Notice of request for more information

Angus Energy Weald Basin No.3 Limited

Application number: EPR/BL9763IN/V005

Supplementary Hydrogeological Risk Assessment (SLR Ltd, 422.07154.00002, Rev 6, August 2020) (Supplementary HRA)

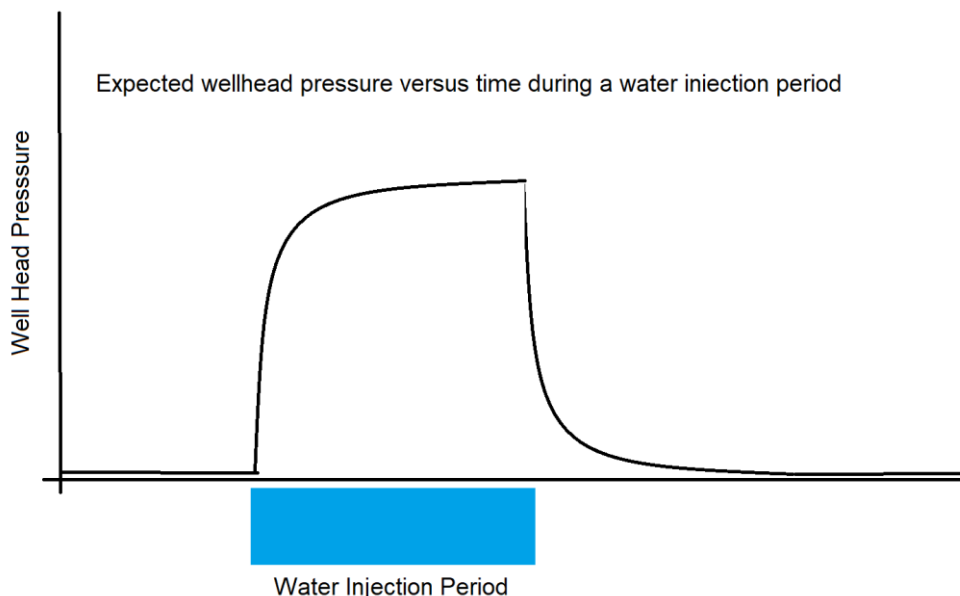
2. Explain how you propose to reconcile the frequent well head pressure readings against the monthly bottom hole pressure readings. You should provide calculations in support of your response.

In response to question 3 of the first Schedule 5 Notice you explained that water injection well head pressures are to be monitored every 30 minutes during injection. We expect there to be a clear calculation as to what this means for bottom hole pressure during daily injection. If measurement of bottom hole pressure itself will only be done monthly, we would expect the daily calculation to be recorded and regularly calibrated against the bottom hole measurements to confirm assumptions about how the reservoir behaviours remain valid.

The monitoring of pressure during injection is to measure the transient short-term effects of injection on the wellhead pressure of the injection well. Within a short time after injection this pressure will fall away as per the diagram below. The purpose of this monitoring is to ensure that wellhead pressure remains within acceptable limited during injection.

In terms of bottom hole pressure the maximum bottom hole pressure during injection is directly proportional to the surface pressure applied. So 100 psi of additional pressure at surface would result in a maximum of 100 psi extra bottom hole pressure (ignoring frictional losses which would tend to reduce the latter).

The difference between the static bottom hole pressure of around 1096 psi (measured in 2021 and to be derived monthly from echometers) and the formation breakdown pressure, at the injection depth, of 1635 psi (a higher estimate of the fracture pressure being 2060) is 529 psi. Therefore up to 529 psi could be applied at surface with no impact on the formation. However, we have included a safety margin in our planning so a maximum wellhead pressure of 350 psi is being used.

The data recording will therefore be as follows:

- A. Previous month's echometer reading of downhole pressure: (say) 1096 psi
- B. Well head injection pressure during 30 minute injections: (limit) 350 psi
- C. A+B must be less than C, lower limit of breakdown pressure: 1635 psi

Updating the monthly echometer to provide a new estimate of downhole pressure not only validates the graph above but also acts as a failsafe to the risk of overpressure as well as a warning sign of any unforeseen trends.

Figure 2-5
2003 USIT Cement Bond Log

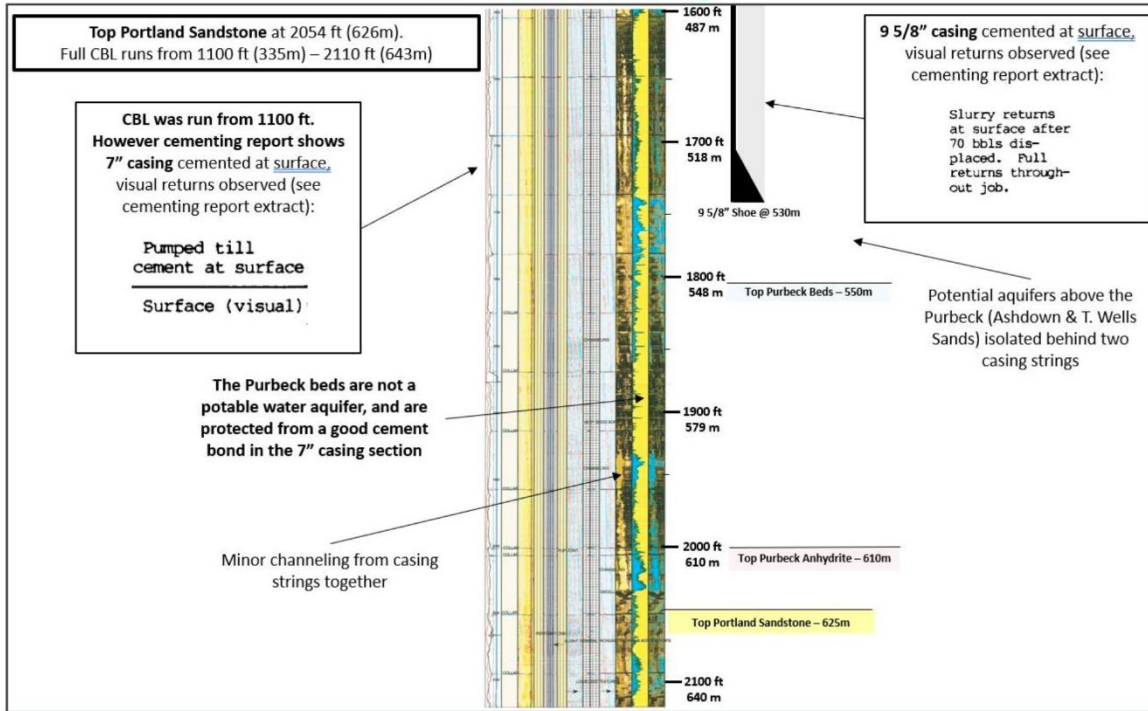
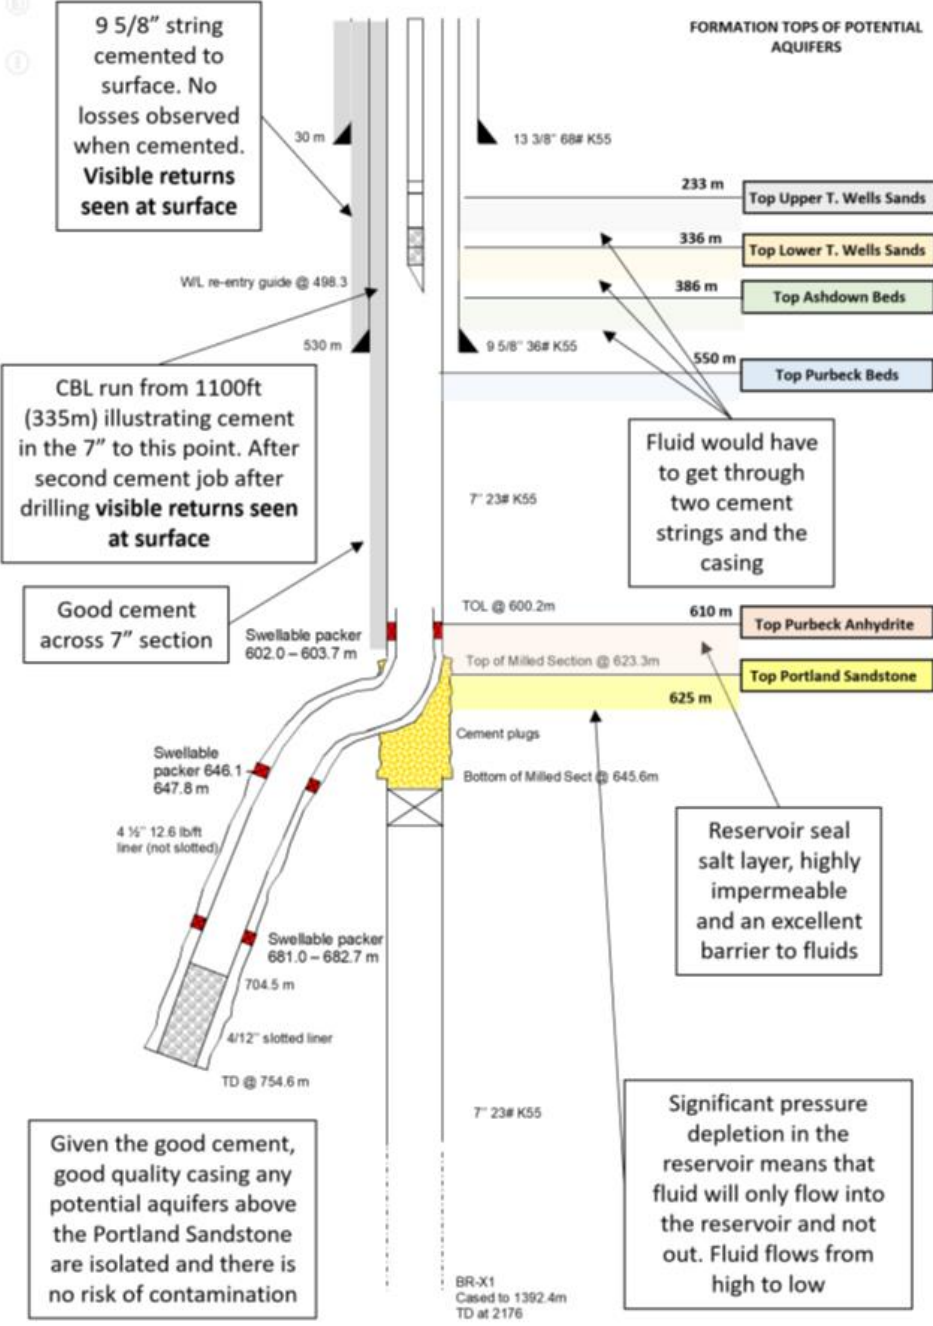
- 4. Provide a more detailed evaluation of the poorer cement bond that has been identified between 550m to 530m BGL. Consideration should be given to any additional risk this poses to the surrounding formations. Please note we have identified a discrepancy between figure 2.5 of the supplementary HRA (v 7 – June 21) and figure 3 in the Schedule 5 Response in terms of the geology that's being shown at 530m to 550m. You should confirm which figure is correct.

The section 530m to 550m corresponds to a 20m section immediately below the 9 5/8ths inch casing shoe. The imperfect cement bond is usual just below casing shoes because on drilling out of the shoe the hole size is usually larger and more irregular making achieving a perfect cement bond harder. Having said that there is cement present as evidenced by the formation returns seen (signal that has passed through casing and cement to the formation and echoed back the same way). This means there is some bond between the casing and the formation via the cement it is just not perfect.

In evaluating this short section of poorer cement bond, we draw attention to the fact that the formation alongside this section is composed of mudstones and shales of Lower Cretaceous age. This formation is impermeable which is why it was selected for the casing shoe. So any fluid present in the well could not enter the formation at this point - even if it were able to pass through the tubing into the annulus and through the casing and the cement.

The vertical barriers of good cement above and below are more than adequate to prevent any annular flow upwards behind casing from the reservoir to the saline aquifers above. This short section of imperfect cement is immaterial to the overall cement barrier. As regards the discrepancy in geology, we reproduce the two figures here, but are unable to see any discrepancy in the descriptions of interval between 530m (casing shoe depth) and 550 m (Purbeck Tops) where the cement bond is poorer.
